**CITY OF ARCADIA
IFB 2025-06 TRIBUTARY F BOX CULVERTS REPLACEMENT**

ADDENDUM NO. 3
City of Arcadia
Margaret Way Building
23 North Polk Avenue
Arcadia, FL 342366

ISSUED: January 20, 2026

ADDENDUM 3
BIDDER'S QUESTIONS AND RESPONSES

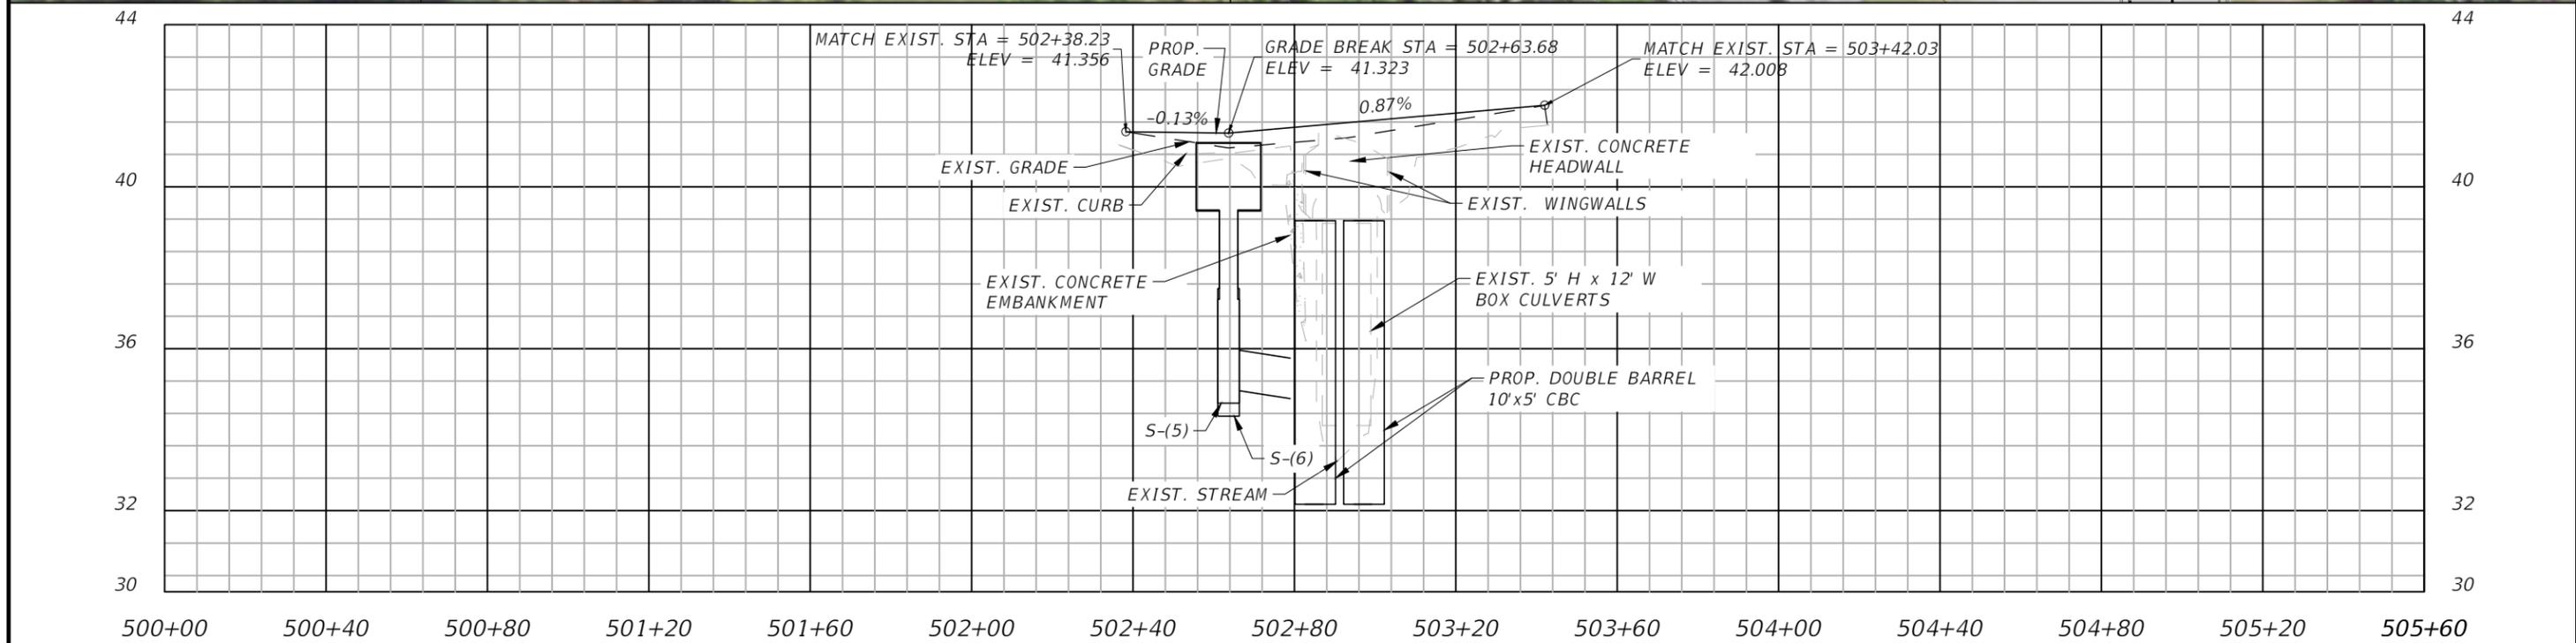
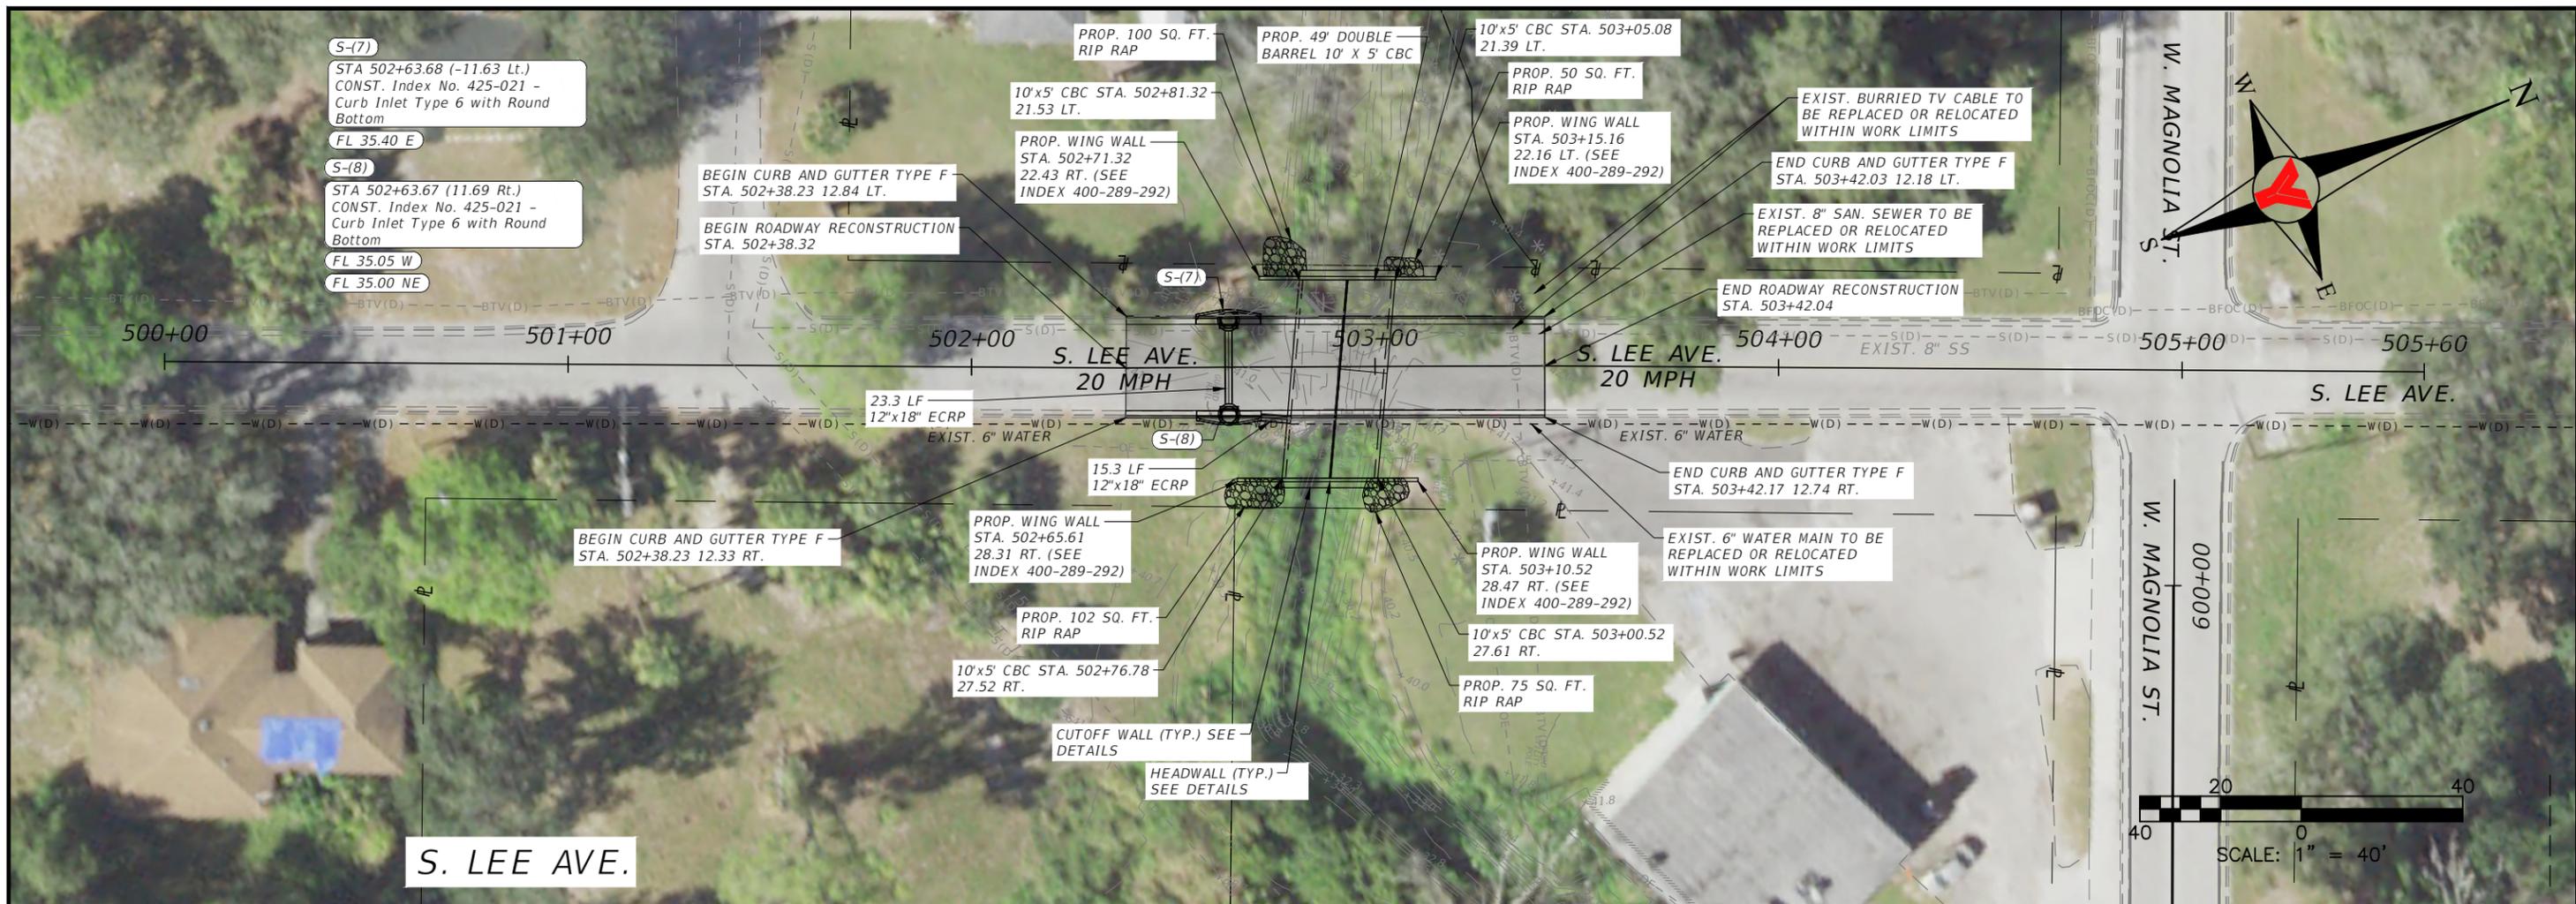
Question 24: The storm drainage @ S. Baldwin Ave. (Sheet R3) does not designate length or size of pipe runs.

Response: **Pipe sizes and length were labeled in the amended plans attached to this Addendum.**

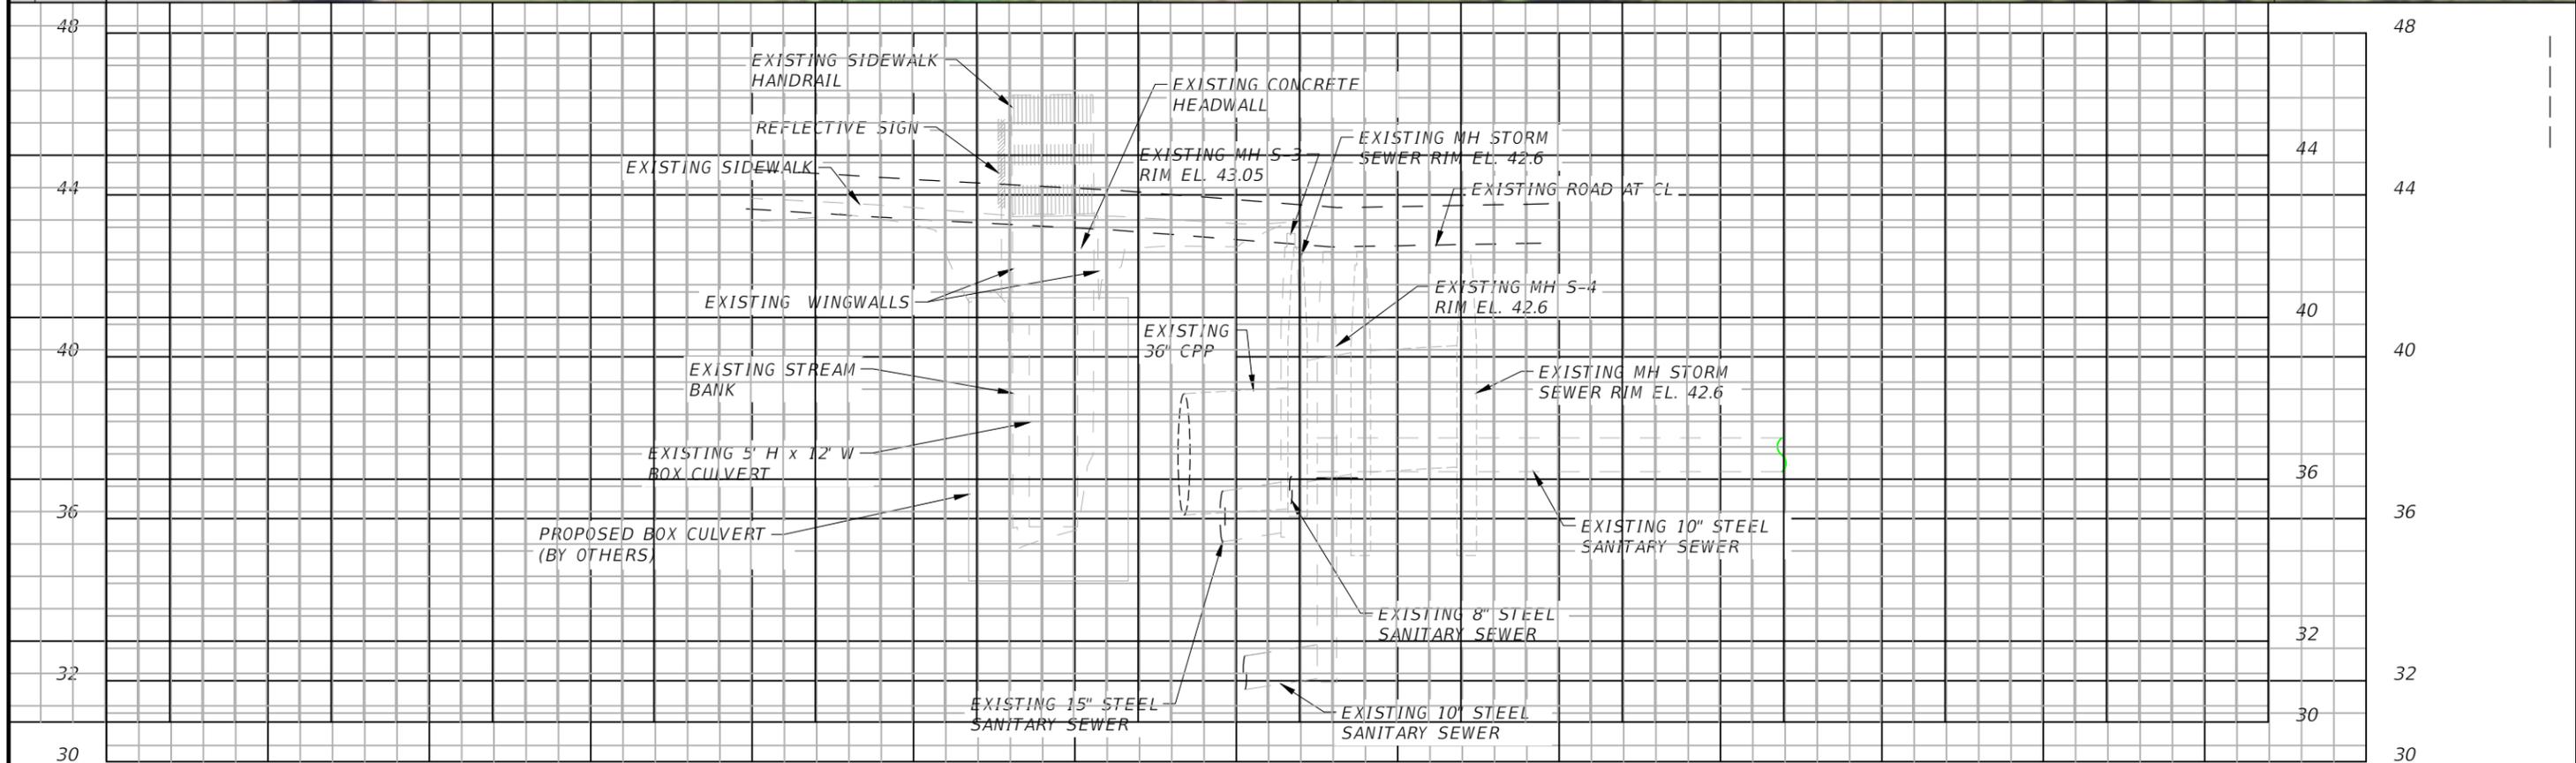
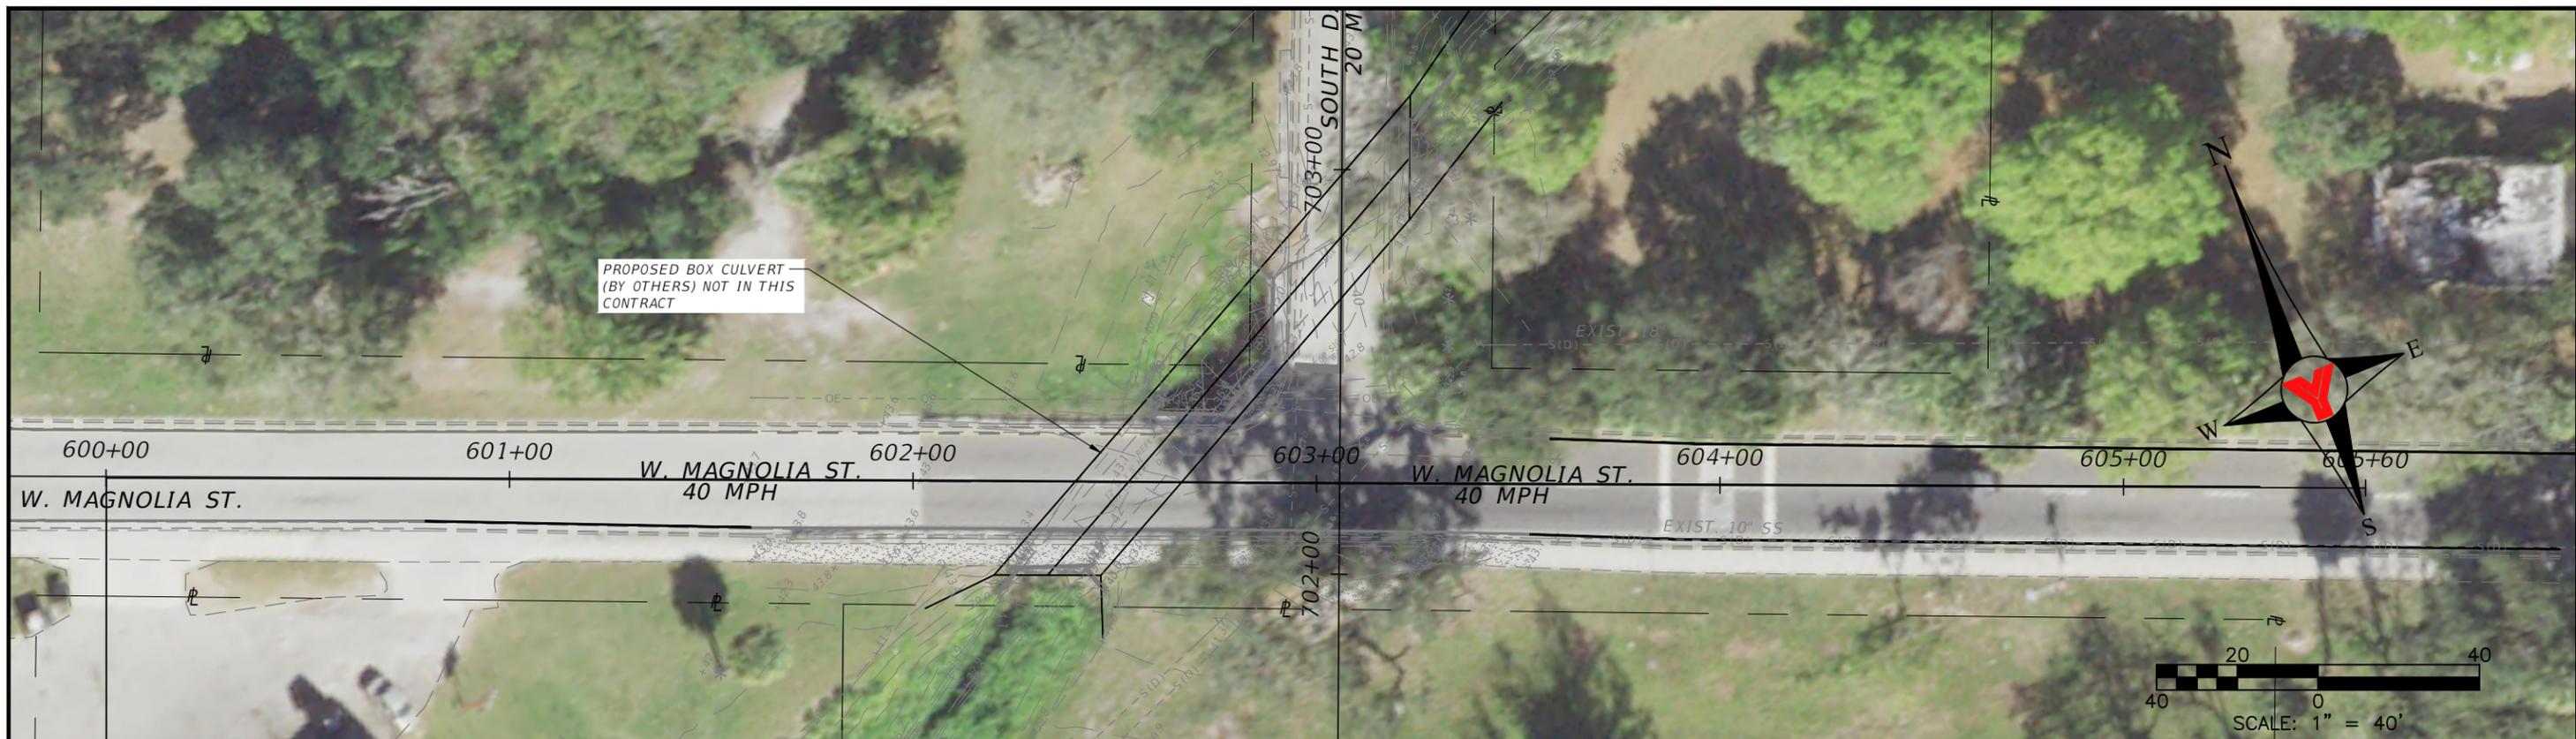
Question 25: The storm drainage between Structures S-7 & S-8 at S. Lee Ave. (Sheet R4) is missing length & size of pipe

Response: **Pipe sizes and length were labeled in the amended plans attached to this Addendum.**
